From: [nadene thorne](mailto:nadene.thorne)
To: manu.koenig@santacruzcounty.us; thekristenbrown@gmail.com; s.brown@cityofsantacruz.com; apedersen@ci.capitola.ca.us; vanessa.quieroz@cityofwatsonville.org; eduardo.montesino@cityofwatsonville.org; felipe.hernandez@santacruzcounty.us; justin.cummings@santacruzcounty.us; bruce.mcpherson@santacruzcounty.us; zach.friend@santacruzcounty.us; rj12@comcast.net; openup@ucsc.edu; [Regional Transportation Commission](#)
Subject: Segment 9, Rail Trail EIR
Date: Tuesday, May 2, 2023 8:12:02 PM

SUBJECT: May 3 2023 RTC Agenda Item 29: Support for Certification of the the Final Environmental Impact Report (FEIR) for Segments 8 and 9 of the Rail Trail,

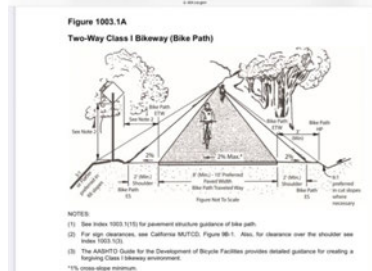
The EIR describes Segment 9 as "a 12-foot trail inclusive of shoulders" with LOS grades of C, D and E. However using 8 feet as width in the SUPLOS calculator scores are mostly F "significant user conflicts should be expected." (5) A trail perceived to be unsafe will discourage use by the most vulnerable users: children, elderly and those with disabilities.

70+00

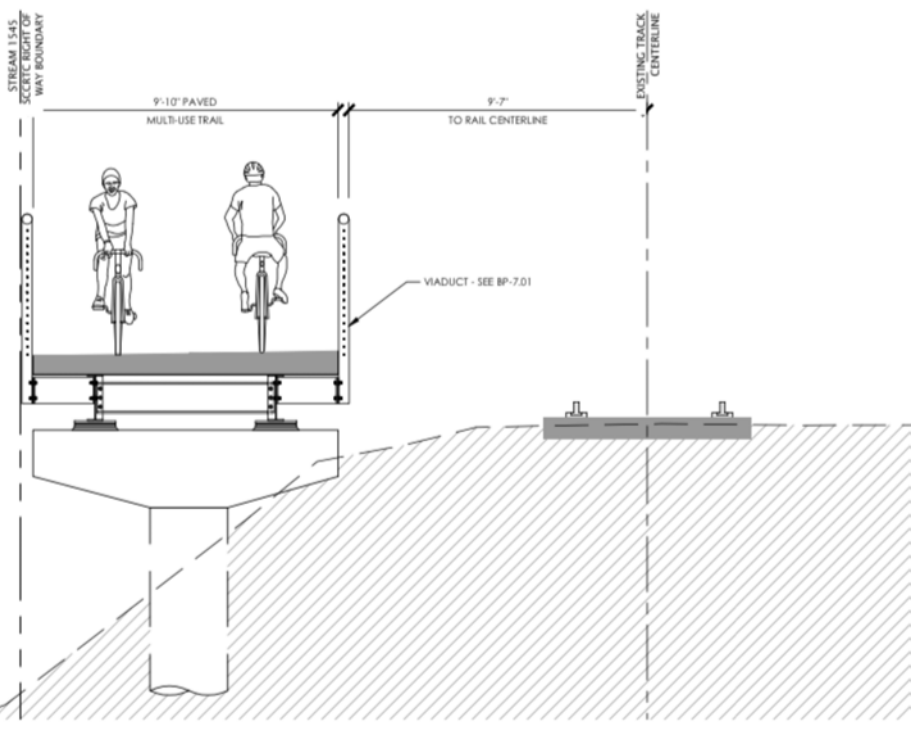
(2) A section of the Ultimate trail alignment near El Dorado narrows to 9'6" (5'6" traveled way). Segment 9 also consists of several viaducts on which the width rule is reduced. CalTrans specifies that "the clear width of a bike path on structures between railings shall not be less than 10 feet." The Li-Oak Viaduct is less than 10' wide.
